From: Pederson Ronda M (AREVA NP INC) [Ronda.Pederson@areva.com]
Sent: Wednesday, October 14, 2009 5:45 PM
To: Tesfaye, Getachew
Cc: BENNETT Kathy A (OFR) (AREVA NP INC); DELANO Karen V (AREVA NP INC); WILLIFORD Dennis C (AREVA NP INC)
Subject: Response to U.S. EPR Design Certification Application RAI No. 273, FSAR Ch. 11
Attachments: RAI 273 Response US EPR DC.pdf

Subject: U.S. EPR Design Certification Application RAI No. 273 (3450, 3459,3460, 3462), FSAR Ch. 11

Request for Additional Information No. 273 (3450, 3459, 3460, 3462), Revision 0

U.S. EPR Standard Design Certification

Figure 11.4-1—Solid Waste

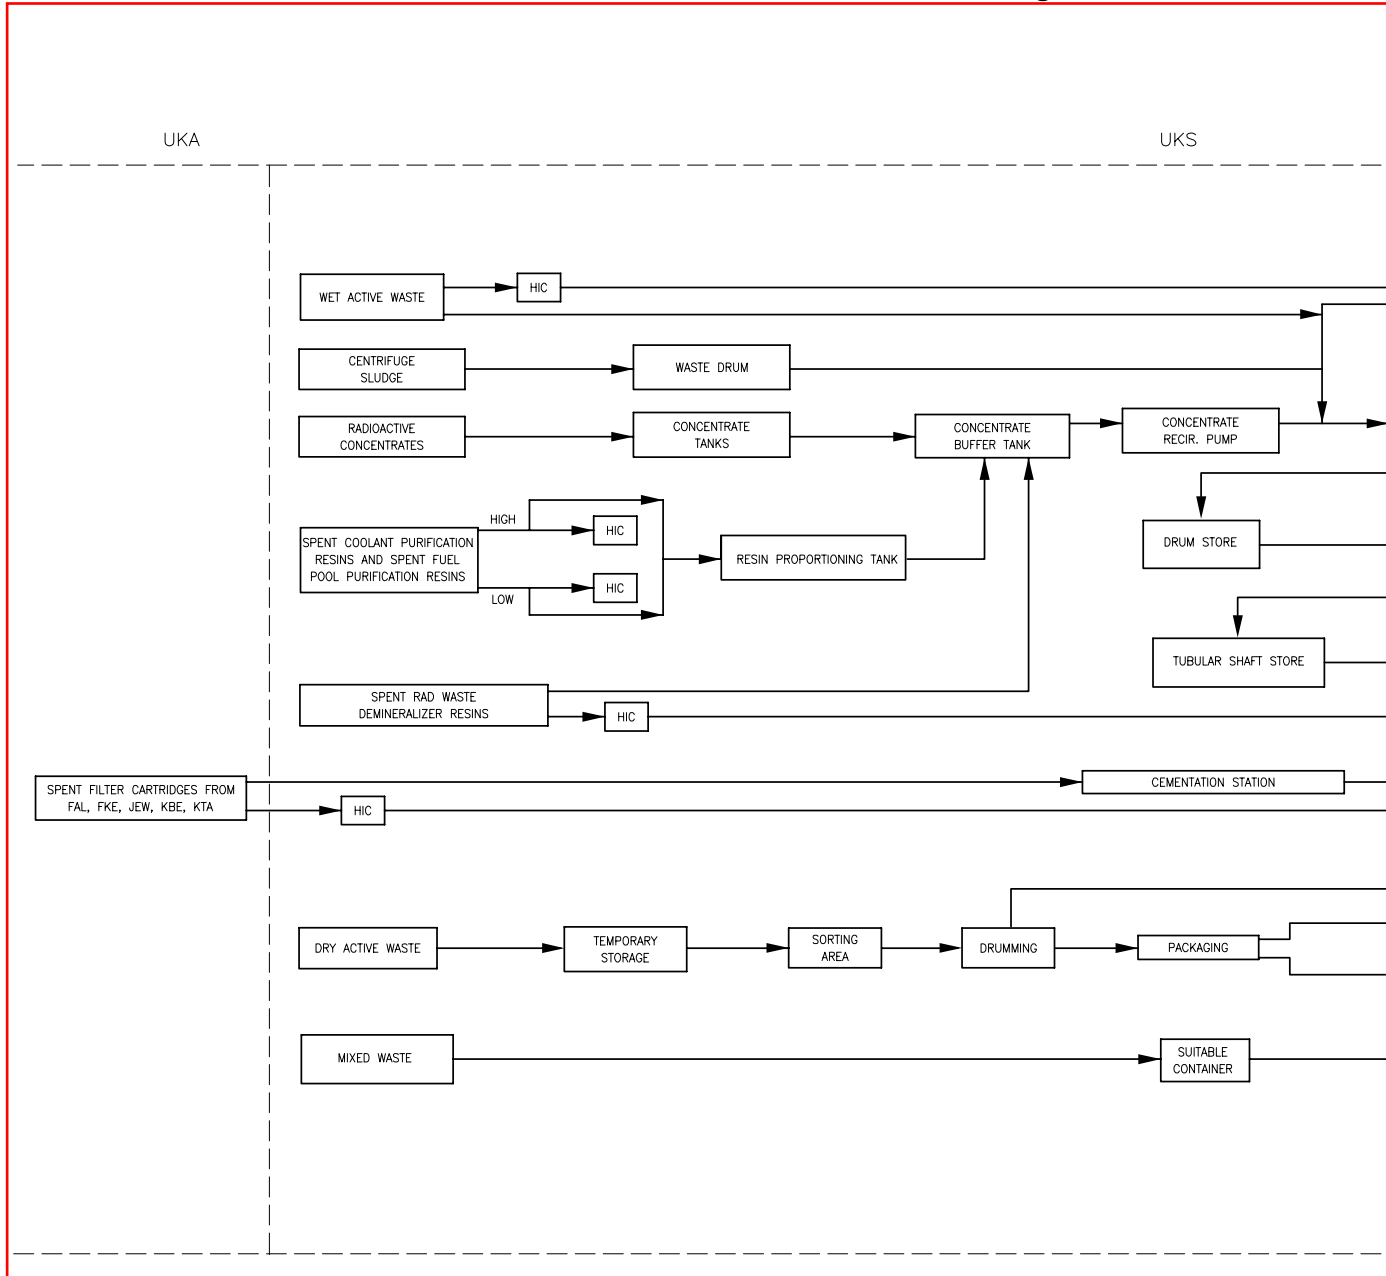
- 5) The location of the Drum Storage Facility and Tubular Shat Storage Facility are shown "On-Site" in Figure 11.4-1 as out of the Radwaste Processing Building, but the text in Section 11.4 implies that that they are located within the Radwaste Processing Building.

5. U.S. EPR FSAR Tier 2, Figure 11.4-1 will be revised to correctly show the location of the drum store facility and the tubular shaft store facility in the Radioactive Waste Processing Building (UKS).

U.S. EPR FSAR Tier 2, Table 11.4-14, and Figures 11.4-1 and 11.4-2 will be revised as described in the response and indicated on the enclosed markup.
